Karen Willey, Chair  
Lawrence-Douglas County Planning Commission  
Lawrence City Hall  
6 East 6th St.  
Lawrence KS 66044

We also wish to assure that all newly planned urban development incorporates bikeway infrastructure by intent, so that difficult and expensive future retrofits do not become necessary. In that regard, I have some observations and requests for bikeways consideration in the 23rd Street Mixed Use Development.

I fully support the development at 1401 W 23rd St & 1300 W 24th St (Opus' KUSH), since new student apartments near amenities will be a community asset. Therefore, these comments are with respect to the developer's choice to use the Smart Code. On principle, this is great news, since the Smart Code represents a shift in thinking about land use: from 1950s-80s auto-oriented Euclidean zoning with segregated uses, it returns to traditional development (form-based) and seeks to integrate uses into complete neighborhoods. The issues I see, however, add up to a general conclusion: *This plan is oblivious to the spirit of the Smart Code* by proposing one large building that is surrounded by lots of parking and set back from the only sidewalk at the property. A Mix

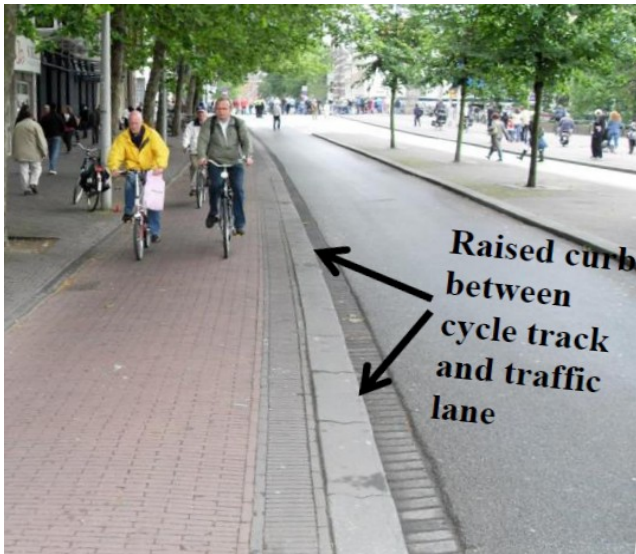
One major north-south spoke passes in immediate proximity to the 23rd Street Mixed Use Development, and should be given particular attention. It extends from Sunnyside Dr. at K.U. south along Naismith Dr. From 23rd St. it extends along the west side of Naismith Dr. to connect with the Naismith Valley Trail that goes all the way to the S.L.T. Trail (part of the Loop). This 2 1/2 mile spoke has a 1/2 mile gap between 23rd St and 19th St. that Lawrence is planning to complete within a year or two.
